Southampton to London Pipeline Project

Comments on Responses to Deadline 6 Submissions

Application Document: 8.95

Applicant's Comments on Responses submitted for Deadline 6

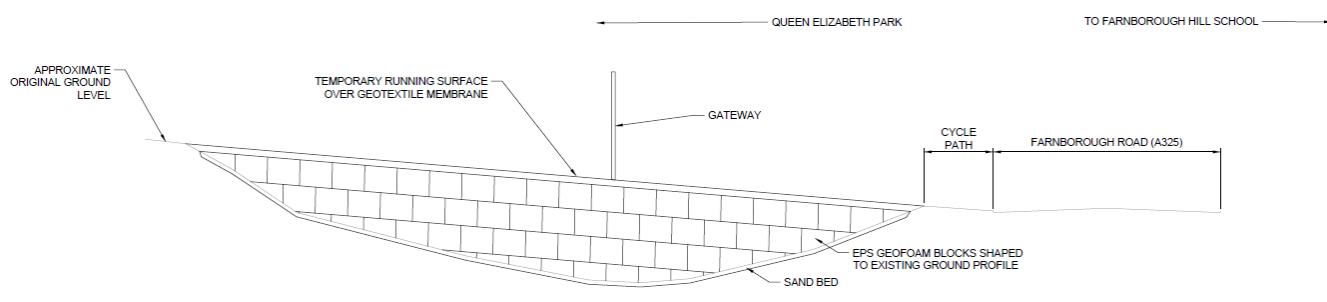
WR Para Ref	Point raised	Applicant response to point raised:
	<p>RBC is intending to commission an expert report from a qualified HDD expert between Deadline 6 and Deadline 7 to enable informed discussion with the applicant on all excavation options before the close of the examination.</p>	<p>The Applicant maintains its position, and notes once again that the Council has advanced no evidence for its position. The Applicant reiterates that it is perfectly feasible to install pipelines through the RPAs of trees using techniques such as air spades, hand digging and vacuum excavation and that for many utility companies this is common practice.</p> <p>The Applicant notes that the Council has had almost six months to commission or provide evidence or a feasibility report stating that HDD is feasible at an appropriate level of risk and yet as the Examination draws to a close, this has still not been forthcoming.</p> <p>The Applicant has provided a number of responses to NUQEP and the ExA during the Examination, expressing its concern with an HDD option beneath the park. The Applicant has now also responded to REP6-110 and REP6-111 at Deadline 7 (Document Reference 8.96) and this includes the provision of borehole data and a Technical Note by subconsultant Horizontal Drilling International (HDI Entrepouse Vinci Group) to further evidence the Applicant's view. The Applicant's response at Deadline 7 (Document Reference 8.96) highlights the lack of evidence provided by the Council and NUQEP in support of the trenchless construction method through the Park which they have proposed.</p> <p>The Applicant has specified a considerable number of areas where trenchless techniques would be used. In particular, there is HDD TC018 feeding into QEP from the west and auger bore TC019 exiting the park to the east and into Farnborough Hill School, so the Applicant has demonstrated that it is not averse to using trenchless techniques where the underlying geology is able to support such an approach.</p> <p>The Applicant has undertaken a number of boreholes in this location to bolster the publicly available borehole detail that is available (Appendix 1). The publicly available borehole data sheets and those now undertaken by the Applicant confirm that the underlying geology is made up of bands of sands and gravels. There are a number of trenchless techniques which work</p>

REP6-087 – Rushmoor Borough Council		
Deadline 6 Submission - Rushmoor Borough Council's response to ESSO comments to submissions and answers to ExA Questions submitted at Deadline 5		
WR Para Ref	Point raised	Applicant response to point raised:
		<p>better in such ground conditions and likewise the ground conditions also dictate what can be achieved from a directional and installation perspective.</p> <p>NUQEP has suggested two additional potential routes and the Applicant has responded later in this document to REP6-110 and REP6-111 to address these. However, the Applicant would raise the following points which apply not only to the routes suggested by NUQEP (Mr Jarman) but to any route that could be proposed:</p> <ul style="list-style-type: none"> • As the Applicant explained at the post hearing meeting with Mr and Mrs Jarman, Mrs Stuart and Ms Salmon on 27 February 2020, the significant challenge is the numerous directional changes which would be required to retain the pipe within the Order Limits. The Applicant does not consider that it would be possible to stay within the Order Limits for this alignment. The drill has an endpoint within Farnborough Hill School which must be met as the length and layout of the pipe string can only be derived from a particular location. To achieve this, not only is the drill required to make vertical changes in direction, it would also have to make horizontal directional changes, which the geology will not readily support. The Applicant may have to undertake several attempts to drive the HDD through due to these ground conditions, which would significantly increase the time works are undertaken within the park. Whilst it may be possible to steer the pilot drill through these numerous directional changes, the risk increases exponentially when the reamer is pulled back, which enlarges the bore to a sufficient size to allow the pipe string to be pulled back. • With horizontal and vertical changes in direction, referred to as a compound curve, and the underlying geology of sands and gravels, it is extremely unlikely that the geology will allow the hole to remain open to allow the string to be pulled back. This is due to the make-up of the substrate of sands and gravels being considered unstable for HDD operations of this magnitude (see attached borehole data at Appendix 1). In order to try

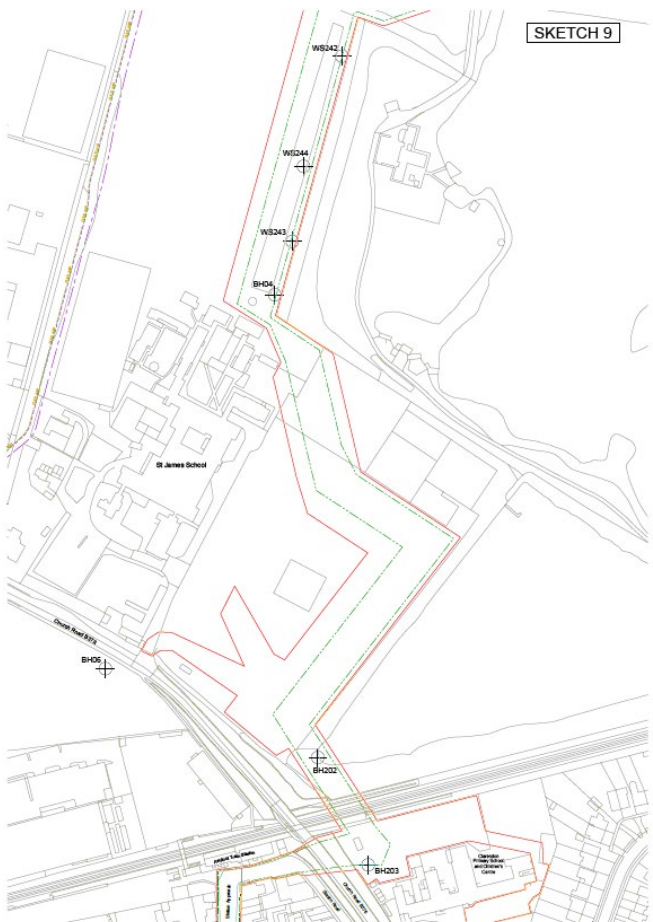
4.1	<p>Consideration of high ground water level</p> <p>Whilst Esso acknowledge that high water levels are a concern for the project (although there was no reference to this in SLT's technical note), it is not correct for them to conclude that this has little bearing on route selection.</p>	<p>The 97km length of the replacement route passes through a number of areas which have similar, if not worse, ground conditions and whilst the underlying high water table does pose some difficulties, these are known and can be managed. Hence the Applicant's comment still holds. The geographical areas along the replacement route north/east of the M25 could all be considered to have a high water table due to the underlying geology of sand and gravels. Therefore, the Applicant will need to take account of the potential for a high water table throughout this area.</p>

4.1	<p>Esso have not addressed our comments in paragraphs 4.3.4 and 5.0 that as ground levels along the western boundary of the school are around 1 metre higher than along Esso's preferred route This will add significant cost and complexity to their preferred option compared to Option 1B</p>	<p>The Applicant is aware of the risk of a high water table when the pipeline is laid along the Applicant's preferred route through St James' School. Whilst this does add some complexity to the pipe laying, there are several other locations along the pipeline route where the Applicant anticipates the need to lay the pipeline where there is a high water table, for example due to the seasonal constraint of having to undertake works in winter through the Special Protection Areas (SPAs). As such, the additional complexity would not be unique to St James' School and the Applicant's contractors would employ the appropriate methodology for such ground conditions.</p> <p>The standard practice for laying steel pipeline is to weld it into a long string section at ground level and only once that string is ready to be laid would the trench for that section be excavated. The pipeline string would then be lifted and placed into the trench as one continuous length. The pipe has sufficient flexibility to enable the end of the string to be left above ground ready to</p>

WR Para Ref	Point raised	Applicant response to point raised:
		<p>Illustration 4: IEAL Sketch 8 identifying IEAL proposed route adjacent to Building B</p>

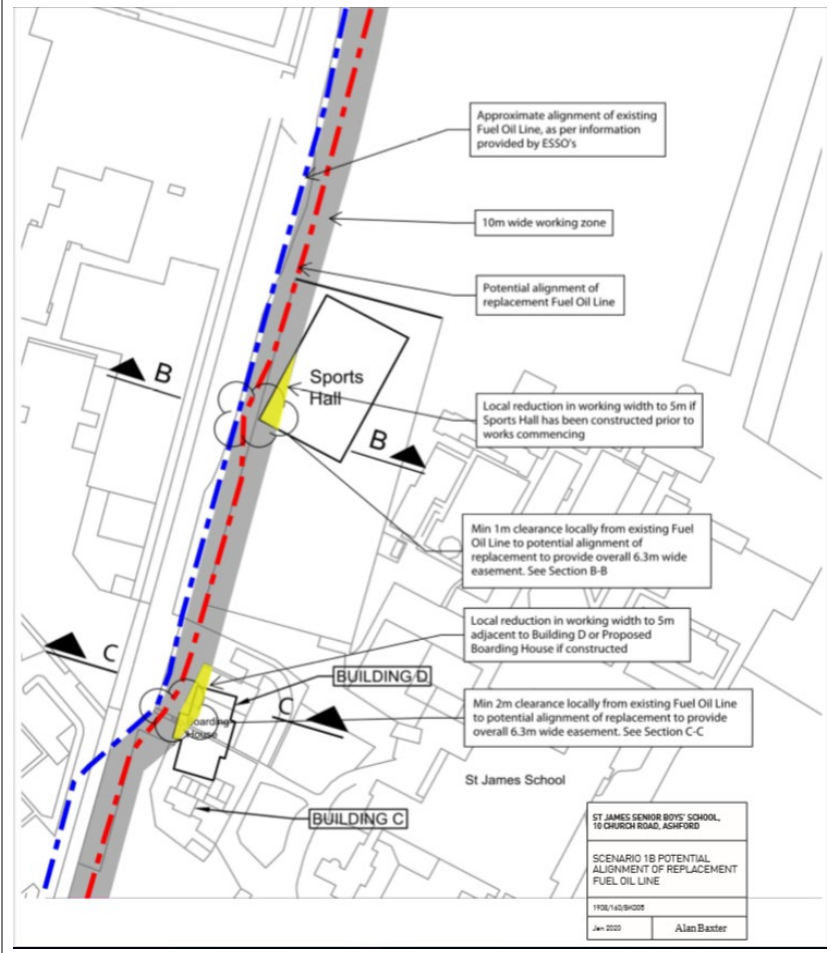
4.3.2	<p>Alignment of option 1B relative to proposed sports hall</p> <p>I do not understand why Esso have felt the need to reiterate that it is not possible to construct a fixed structure over the new or existing pipelines as that is not a consequence of Option 1B.</p>	<p>While the school could amend the size or layout of the approved building, the Applicant must have regard to the existing planning permission at the point of designing a route. Permanent buildings, such as a sports hall, cannot be constructed within the pipeline easement. This is particularly relevant as the school's alternative route would conflict with the existing planning permissions.</p>

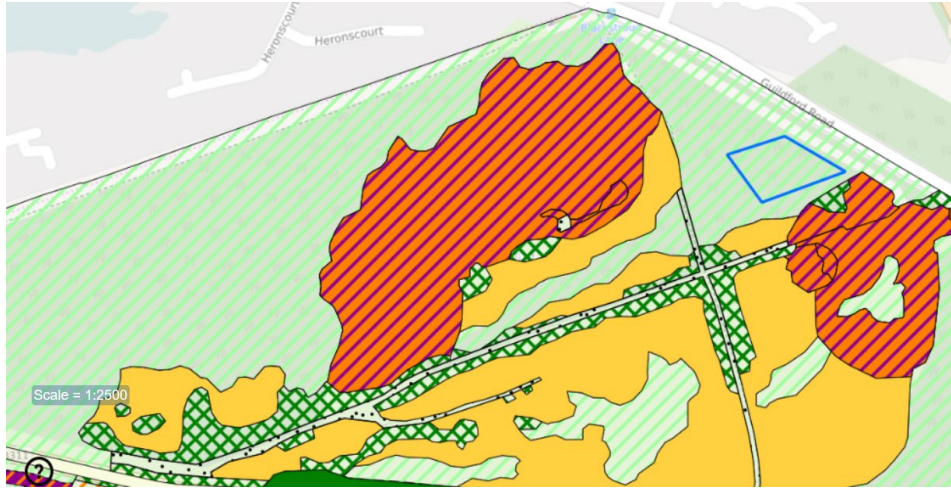
REP6-106 – Heronscourt and Colville Gardens Residents Associations Deadline 6 Submission - Comments on responses submitted for Deadline 5		
WR Para Ref	Point raised	Applicant response to point raised:
Cover email	<p>Natural England letter</p> <p>Statement that Natural England advised Michael Gove that "...it is our advice that either route would be deliverable with the right package of avoidance and mitigation..."</p> <p>Copy of the text of the letter from Natural England included at Appendix 3 of this Deadline 6 submission.</p>	<p>The Applicant would like to point out that Natural England has informed that the letter referred to in REP6-096 was written in August 2019 without input from the relevant Case Officer, who was on leave at the time. The Applicant has also been in ongoing discussions with Natural England and believes that there is now a greater understanding of the trees likely to be impacted.</p> <p>There is no new information provided within this email that would change the route selection in Turf Hill.</p> <p>In paragraph 3, Natural England is pointing out the difference between F1c 'heathland which is known to be of value to Dartford Warblers and sand lizards' and F1a+ which 'passes through woodland, although mature... does not support the features for which the sites have been designated'. This clearly supports the Applicant's case that F1a+ does not affect the designated habitats.</p> <p>Although impacts on protected species could be reduced through mitigation measures such as trapping and relocating, the Applicant considers that the best form of mitigation is avoidance.</p> <p>Natural England states, 'However, we do recognise that the woodland may contain some veteran or other important trees. Natural England is working with the Forestry Commission and the applicant to ensure that these trees are not significantly harmed by the application.' The Applicant would note that the arboricultural survey has confirmed that there are no veteran trees identified.</p> <p>The Applicant has selected a route which reduced the potential damage to optimal habitat used by protected species. The Applicant remains confident in its route selection.</p> <p>The Applicant has always made clear that Natural England provided information on both routes and did not express a preference (see TH.1.8 in REP2-049 & TH.2.2 in REP4-028). The route</p>

REP6-106 – Heronscourt and Colville Gardens Residents Associations		
Deadline 6 Submission - Comments on responses submitted for Deadline 5		
WR Para Ref	Point raised	Applicant response to point raised:
		<p>selection was undertaken solely by the Applicant based on the evidence available. Further, the route selection was not based upon a single issue, as set out in the Applicant's responses to relevant representations (REP1-003, pages 84 – 88 (inclusive)).</p> <p>The Applicant can confirm that Natural England has expressed support for the overall project through its response on the Habitats Regulations Assessment Report (Application Document APP-130 and APP-131) and as evidenced within the Statement of Common Ground between the two parties (REP1-005).</p>
Cover email	<p>Requests for information</p> <p>Request for a full tree survey to the necessary British Standards to quantify tree loss accurately.</p> <p>Request for a survey of the Affinity Water pipeline.</p>	<p>A full tree survey to BS 5837 has been undertaken and the results relating to the removal of trees is contained within the Turf Hill Site Specific Plan submitted at Deadline 6 (REP6-053).</p> <p>The full tree survey has been submitted at Deadline 7 (Document Reference 8.97).</p> <p>The Applicant can confirm that utility data was originally obtained from Landmark in March 2018, which included the location of the Affinity Water main, and this information was used by the Applicant to inform the route through this location.</p> <p>Affinity Water will be undertaking an intrusive survey to confirm the location of its main, to ensure that this is line with the data received by the Applicant.</p>

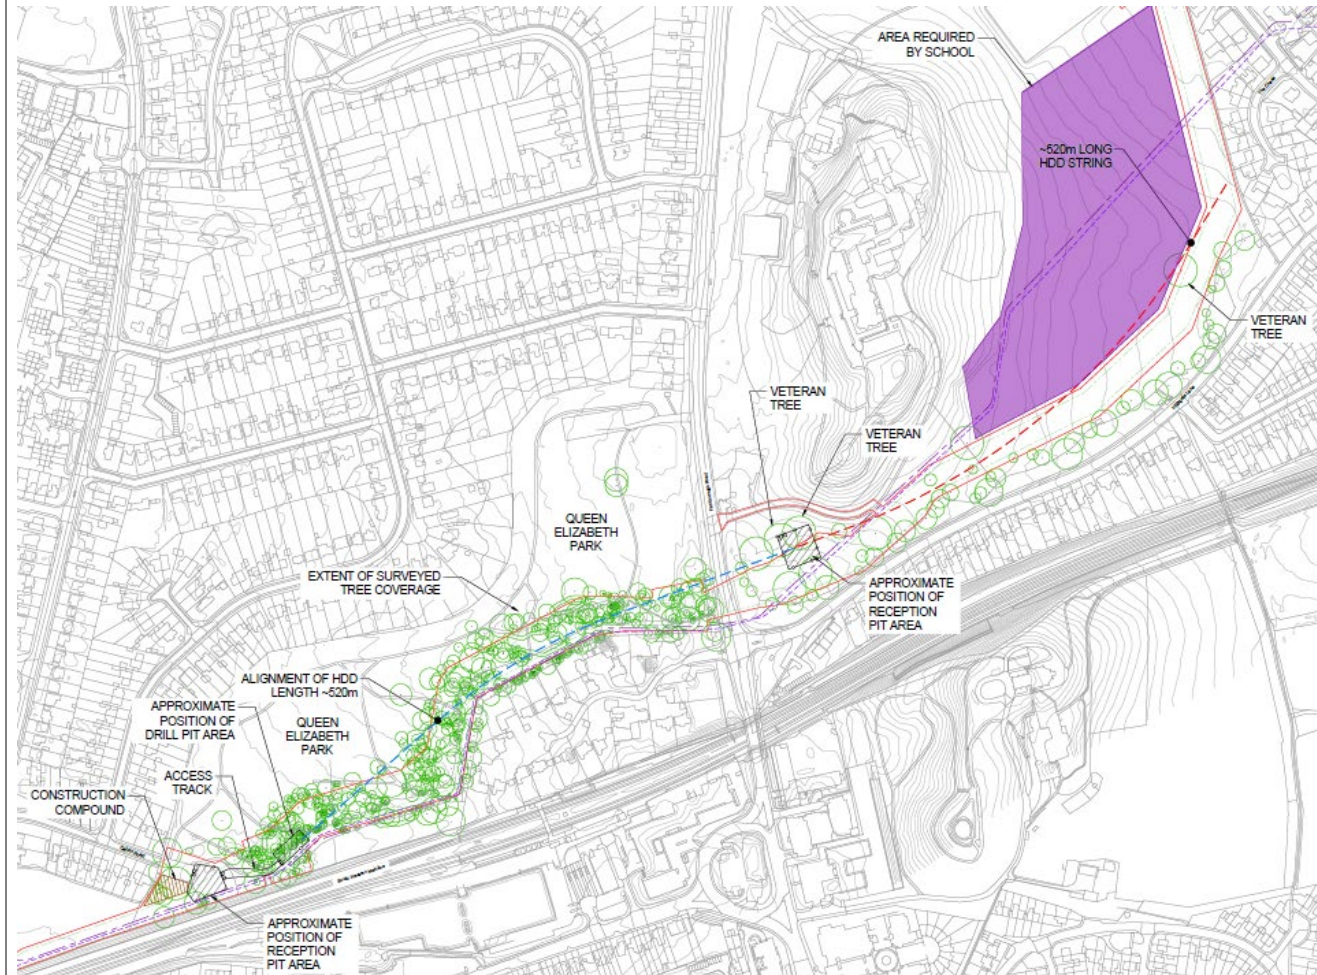
- The Applicant has overlaid the proposed drill pit area onto a layout of the park. In sizing this area, it would appear that the author of the proposal (Mr Jarman) has made some incorrect assumptions and that the size of the working area would need to increase from the size shown by Mr Jarman in order to accommodate all of the Applicant's necessary equipment.

REP6-111 – Nick Jarman on behalf of Neighbours and Users of Queen Elizabeth Park Deadline 6 Submission - Responses to Action Points arising from the Hearings week commencing 24 February 2020		
WR Para Ref	Point raised	Applicant response to point raised:
		<p>The Applicant can advise that in this location there is a slight gradient and that, as a consequence, any topsoil that would be stripped from this area would need to be stored in a safe and secure area so that it does not get contaminated with any of the bentonite which would be used to undertake the drilling. The Applicant has made modifications to Mr Jarman's layout to allow for such an area.</p> <ul style="list-style-type: none"> • In order to create this worksite area, a haul road would need to be constructed from the Cabrol Road car park, so that the heavy plant and machinery can be safely delivered to the worksite. The plant and machinery that would be required for the open cut method does not require significant works to be undertaken to the existing track as the plant and machinery is much lighter. However, the drilling rig and all the associated plant is considerably heavier and would require a heavy-duty haul road to be laid. Building the haul route would also require the import of suitable material, such as graded backfill and MOT Type 1. The haul route would not necessarily require a wearing course, but this is dependent on seasonal constraints and the time of year that the works are undertaken. • Having reviewed this proposal against the tree survey, it is apparent that this would result in the removal of 28 trees including three mature trees as opposed to the 30 non-mature trees requiring removal for the Applicant's open trench proposal. Mr Jarman states that this tree clearance can be tolerated, however there is no evidence that this would be acceptable to other Interested Parties, such as Rushmoor Borough Council. Protective measures would be required for the RPA of at least one notable tree crossed by the haul road. • As the Applicant explained at the post hearing meeting with Mr and Mrs Jarman, Mrs Stuart and Ms Salmon on 27 February 2020, the significant challenge with this alignment is the numerous directional changes which would be required to retain the pipe within the Order Limits. The Applicant does not consider that it would be possible to stay within the Order Limits to be able to achieve this alternative route. The drill has an endpoint within Farnborough Hill School which must be met as the length and layout of the pipe string can

Illustration 17: Copy of Illustration 16 with aerial photography overlay to show the trees

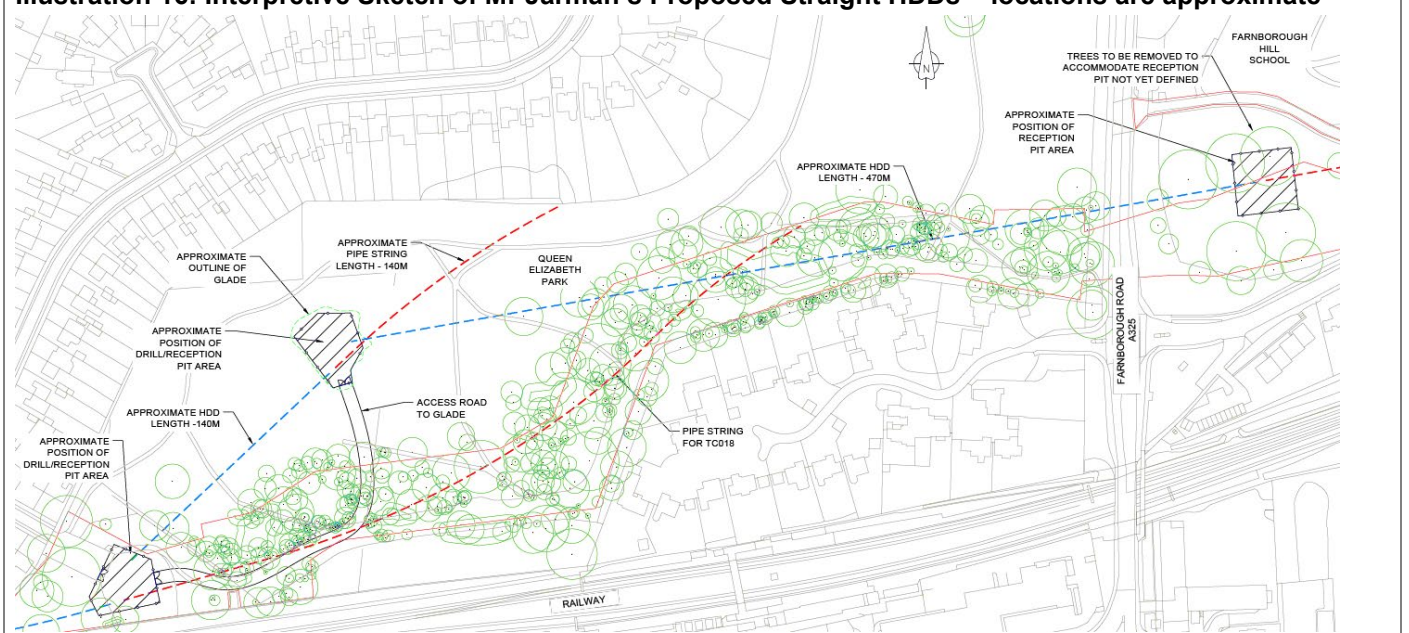
WR Para Ref	Point raised	Applicant response to point raised:
		<p>The Applicant's primary concern is to install the replacement pipeline with minimal impact and, with the benefit of engineering experience the Applicant has been very clear that a trenchless technique through this section of the route does give rise to significant risks over and above those which would occur from an open trench technique through this area.</p> <p>The Applicant's proposal also protects the notable and veteran trees within the park.</p> <p>The Applicant has clearly identified those trees which would need to be removed and all are of a low quality and spread over the length of the park, whereas the proposal by NUQEP would require a large rectangular area to be stripped bare of all vegetation.</p>
3	Straight Bore Option	<p>In response to the option to use a straight bore option, the Applicant assumes that the NUQEP are proposing that two HDD are used: one to get to the middle of the park and a second to route under the park, beneath the A325 and emerging in Farnborough Hill School.</p> <p>Illustration 15: Proposed two HDD submitted by NUQEP</p>  <ul style="list-style-type: none"> The Applicant would firstly advise that such a proposal has never been shared with the Applicant. This option is located outside of the Order Limits and has been provided very late in the examination process. The Applicant has not surveyed this area of the park, given

WR Para Ref	Point raised	Applicant response to point raised:
		<p>it is outside of the Order Limits, so is unable to make an informed response and can only respond to the statements as raised by NUQEP.</p> <p>Illustration 16: Interpretive Sketch of Mr Jarman's Proposed Straight HDDs – locations are approximate</p>
